**Coolant Leakage – Cylinder Head Gasket –  
Revised Gasket Design**

MODEL 1995-97 MY  
Sedan (4.0L) Range  
VIN  
720001-ON

ILLUSTRATION 1

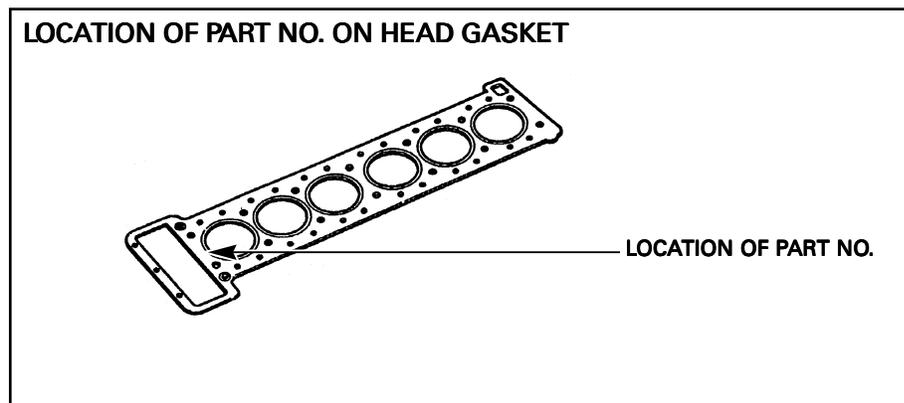
A revised head gasket, which is more resistant to coolant leakage, has been introduced into production from engine no. B168652 at VIN 794099.

The revised gasket can be identified by the part no. stamped on the gasket near the word "TOP" (Illustration 1). Two part numbers are available depending on the engine no.

When replacing the cylinder head gasket on all AJ 16 engines, always verify that you are installing the revised head gasket, **as well as the correct gasket for the engine number.**

For engines up to engine no. B107672 Normally Aspirated  
or B107674 Supercharged use NBC 2520BB

For engines from engine no. B107673 Normally Aspirated  
or B107675 Supercharged use NBC 2520AB
